SUB-COMMITTEE ON STABILITY AND  
LOAD LINES AND ON FISHING VESSELS  
SAFETY

SLF 55/INF.XXX  
XXX October 2012  
Original: ENGLISH

## DEVELOPMENT OF PROVISIONS TO ENSURE THE INTEGRITY AND UNIFORM IMPLEMENTATION OF THE 1969 TM CONVENTION

### Information collected by the Correspondence Group

**Issue 3.f - Treatment of Hull Spaces of Complex Shape (SLF 53/5, annex 4, issue No. 23)**  
Column-stabilized units, such as semi-submersible drilling units, and ships of similar design are often fitted with cross-bracing, for which volumes can be extremely difficult to calculate.

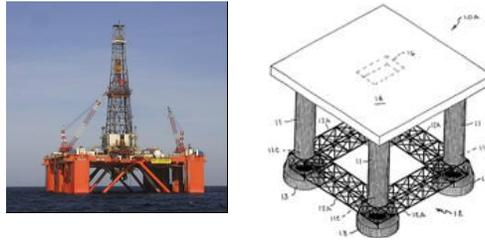
**Proposals** The group considered three proposals. One proposal recommended development of clear definitions as to what should and should not be included in tonnage, with the method for determining volumes left to the naval architect's discretion. Another proposal recommended specific definitions for the terms "hull" and "appendage" based on discussions at SLF 30, with appendages to include structures fitted on the outer surface of the hull, whether solid or bounded by a metal cover. The third proposal recommended the inclusion in tonnage of all appendages, bracings, and other linear hull elements that are larger than 1 m<sup>3</sup> in volume, with provisions to approximate volumes of such items.

**Questionnaire Responses** Most agreed, with comments, on the proposals to develop clear definitions and include in tonnage appendages and bracings larger than 1 m<sup>3</sup> in volume, with less agreement on the remaining proposal related to the specific definitions. Several respondents commented to the effect that if definitions are clear, interpretations regarding allowable computational approaches could add unnecessary complexity, while another cautioned against including definitions that are overly detailed. Several respondents questioned the application of both volume and area criteria in measuring smaller spaces, with one advocating inclusion of the space in tonnage if the volume and/or area criteria are exceeded. Another questioned the treatment under the proposed definitions of a hollow appendage fitted to the hull that is open to the hull at the point of connection.

**Issue 3.h - Vertical Truss Structures (CG Round 1)** Self-elevating drilling units are often fitted with vertical truss structures (e.g., legs and rigs). Currently, there are no clear instructions on measurement of the truss structures. Clarification would be helpful to ensure a uniform approach.

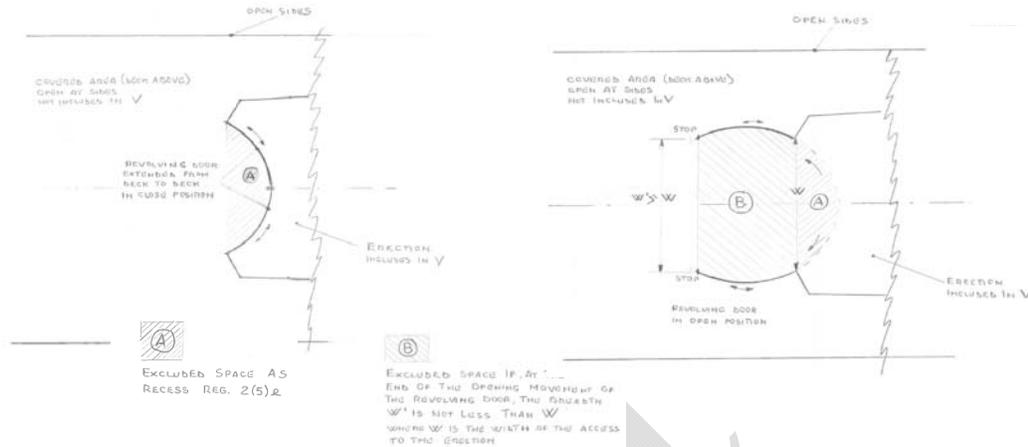
**Proposals** The group considered a single proposed solution, recommending that truss structures such as the legs and rigs of self-elevating drilling units not be included in tonnage.

**Questionnaire Responses** A majority of respondents agreed with the proposal, with one respondent commenting on the acceptability of the approach for any truss structures for which it is not possible to identify an enclosed volume. Among those who disagreed, one respondent preferred that the volume of such structures be included in tonnage if the entire assembly is greater than 1 m<sup>3</sup> in volume, without regard to whether or not the structure is movable. Another commented that truss structures on some semi-submersible drill rigs are used to adjust buoyancy during towing, and therefore should be included in tonnage. Another questioned whether these ships could be treated under novel craft provisions, noting that the structures in question occupy “space” both above and below the waterline.

Figure 1: A ship fitted with spaces between the inner skin and the outer shell to fill air for buoyancy

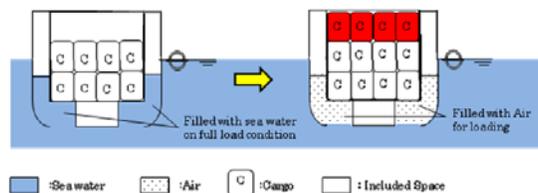
**Issue 6.d - Large Volumes of Spaces Open to the Sea (SLF 53/9/5)** Some ship designs have been developed to obtain additional buoyancy or an additional cargo capacity with no increase in the gross tonnage, making use of the open to the sea provisions regulation 6(3) to effectively reduce the ship's gross tonnage. Examples of such designs are: 1) ships with open bottom spaces between the inner skin and outer shell that hold air to gain additional buoyancy (figure 1); and 2) ships with cargo spaces between cross-deck structures with gratings openings to the sea (figure 2). The volumes of such spaces can be substantial, relative to the total volume of the ship.

**Proposals** The group considered four proposals. Two proposals recommended the interpretation along the lines that spaces open to the sea, used or appropriated for holding cargo, and/or contributing to the buoyancy of the ship, should be included in tonnage. One proposal recommended the interpretation that the space must be in free communication with the sea at all times. The remaining proposal recommended that tonnage not be calculated with respect to the use of a space, but that spaces that are not always open to sea or are fitted with a means for securing cargo cannot be excluded.

**Questionnaire Responses** Most respondents either agreed with all of the proposals, or agreed subject to changes. In commenting on the proposal regarding free communication with the sea, one respondent cautioned that the language must address stern chutes and hawse pipes. Another respondent stated agreement in principle with this proposal, subject to including the provision that a space open to sea may not be excluded if used for the carriage of cargo, and noting that this approach would address situations where trapped air could prevent water from entering a tank. Another respondent expressed the view that there should be no linkage between exclusion of a space as open to sea and whether or not the space is buoyant or carries cargo or stores.

figure 7 Unified Interpretations Proposal 1.b.6

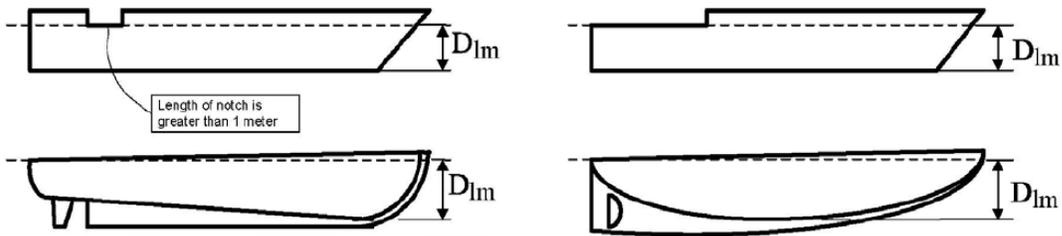
**Proposal 6** Establish a new Interpretation of A.2(2)-X, which reads: “The term “least molded depth” means the vertical distance between: 1) the top of the flat plate keel (or equivalent) at the lowest point along its length; and 2) the horizontal line that is tangent to the underside of the upper deck at the ship's side at the lowest point along the upper deck's length. For the purposes of this definition, the ship is considered to be trimmed on a waterline parallel to the design waterline.” (insert figure 7, found at the end of this annex)

figure 8 Unified Interpretations Proposal 3.a.7

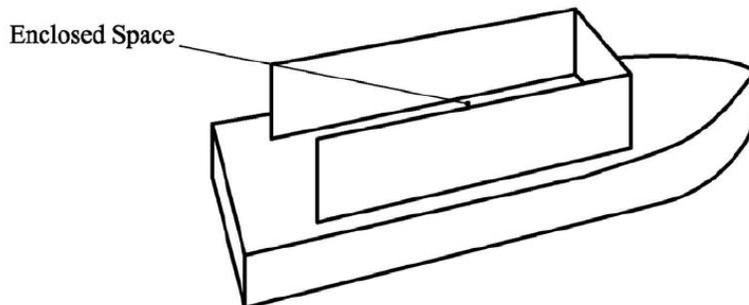
**Proposal 7** Revise Interpretation R.2(4)-1 to read: "The absence of a deck or covering does not preclude a space from being treated as an enclosed space, provided it is bounded on at least three sides by fixed or portable partitions or bulkheads, or by the hull." (insert figure 8, found at the end of this annex)

figure 9 Unified Interpretations Proposal 3.a.8

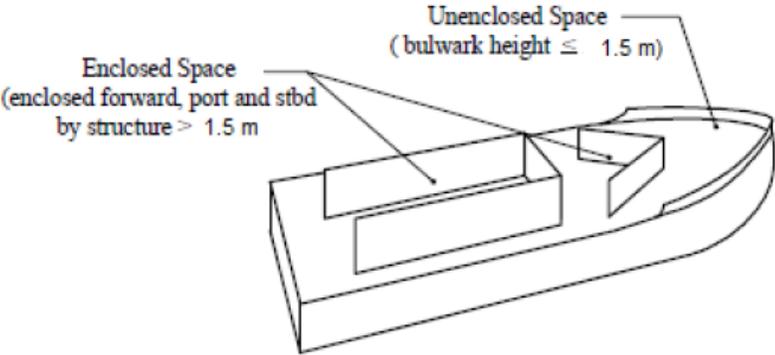
"In the situation where only a portion of a bulkhead or partition exceeds 1.5 m in height, the entire inboard space in way of that portion of the structure from the deck to the top of the structure must be included in the total volume of all enclosed spaces (V)." (insert figure 9, found at the end of this annex)

figures 10 & 11 Unified Interpretations Proposal 3.i.1

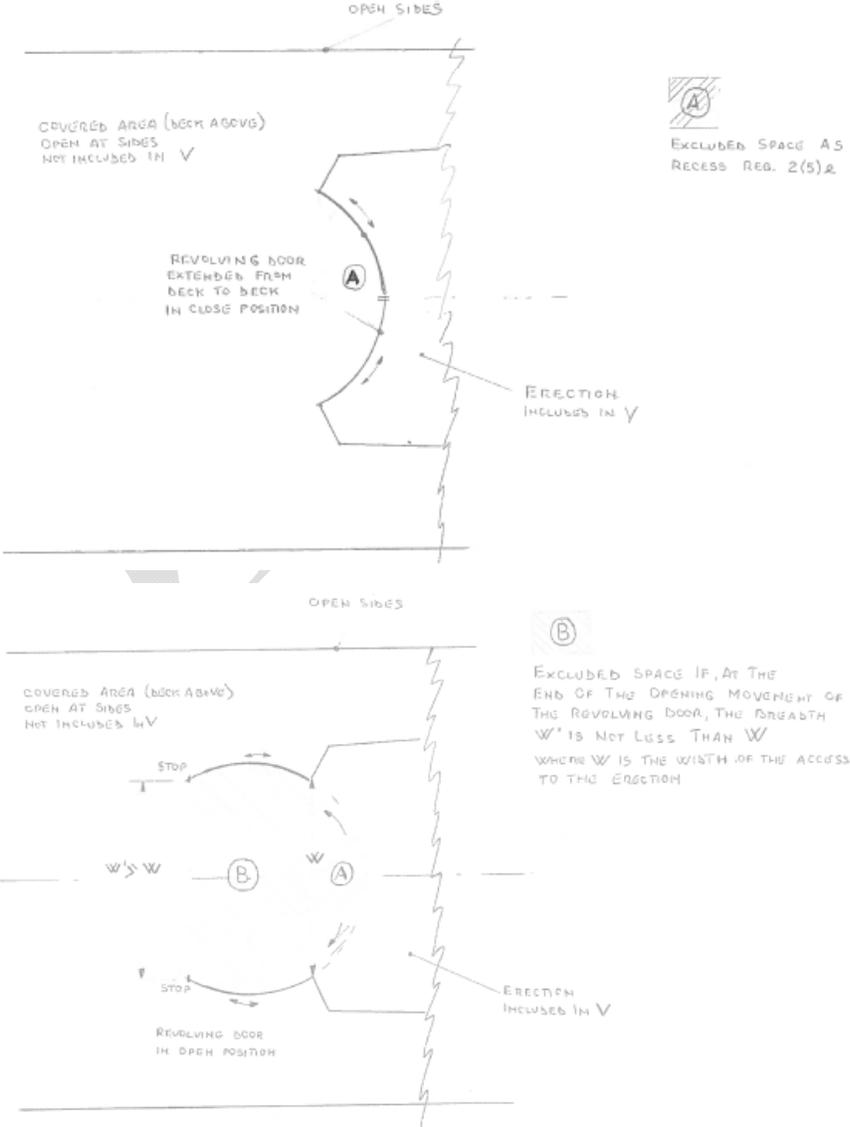
**Proposal 1** Establish a new Interpretation R.2(5)-X, which reads: “The space bounded by a door, placed in an erection in a covered area, is not included in the total volume of all enclosed spaces (V) if, at the end of the opening movement of the revolving door, the breadth  $W'$  (breadth of access in open position) is equal to or greater than the breadth of access  $W$  (breadth of access in closed position)”. (insert figure 10 and 11, found at the end of this annex)

figure 12 Unified Interpretations Proposal 5.c.1

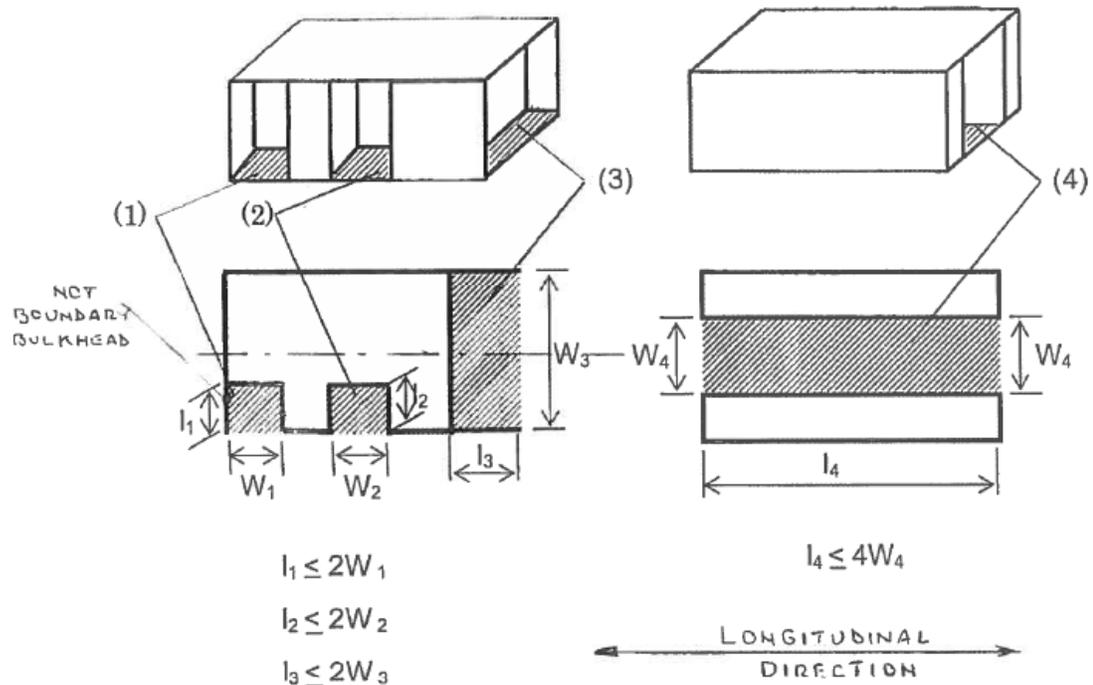
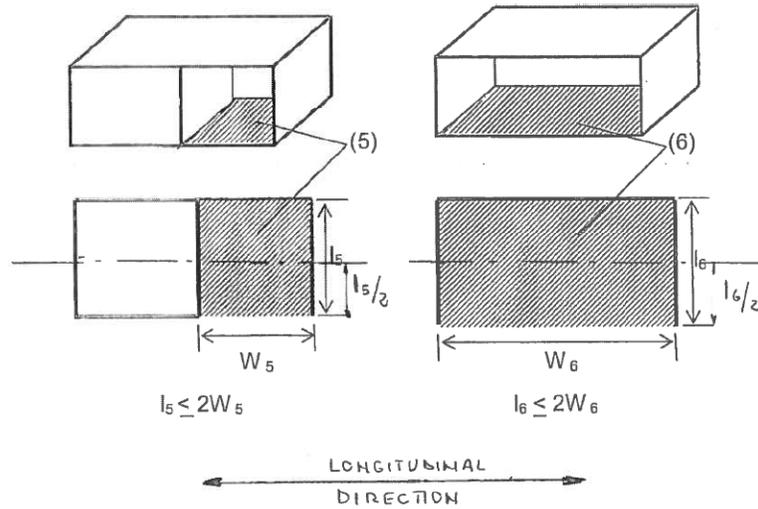
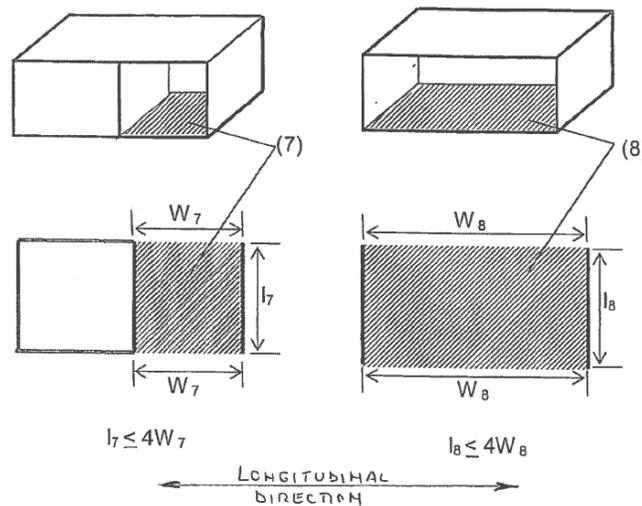
deck to deck from more than one tier.” Additionally, establish a new Interpretation R.2(5)(c)-X, which reads: “A space in an erection, directly in way of opposite side openings should be excluded. If the opening in such an erection is provided on one side only, the space to be excluded shall be limited to a maximum of one-half of the breadth of the erection.” (insert figure 12, found at the end of this annex)

- (1) It is not a recess – Bounded by only two boundary bulkheads – It should be excluded due to the side opening.
- (2) It is a recess – Bounded by three boundary bulkheads – It should be excluded.
- (3) It is not a recess – Bounded by only one boundary bulkhead – It is a space within an erection opposite an and opening and it can be excluded only if the provision of the Reg. 2(5)(a)(i) are met.
- (4) It is not a recess - Bounded by only two boundary bulkheads – It is a space within an erection opposite an and opening and it can be excluded only if the provision of the Reg. 2(5)(a)(i) are met.

- (5) It is not a recess – Bounded by only one boundary bulkhead –  
Should be excluded a space limited inboard from the side opening to one-half of the breadth of the erection ( $l_5/2$ ), due to the only one side opening.
- (6) It is not a recess – There are not boundary bulkhead –  
Should be excluded a space limited inboard from the side opening to one-half of the breadth of the erection ( $l_6/2$ ), due to the only one side opening.

- (7) It is not a recess – Bounded by only one boundary bulkhead –  
Should be entirely excluded due to the two sides opening.
- (8) It is not a recess – There are not boundary bulkhead -  
Should be entirely excluded due to the two sides opening.

figure 13 Unified Interpretations Proposal 5.h.1

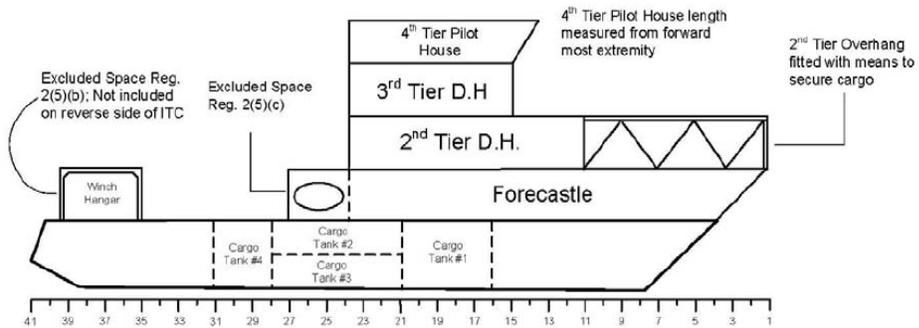
**Proposal 1** Establish a new Interpretation R.2(5)(a)-X, which reads: “The 25 millimeter curtain plate depth criterion should be applied to the portion of the curtain plate that extends below the lowest extremity of the adjoining deck stiffeners.” (insert Figure 13 in the Round 2 Questionnaire annex)
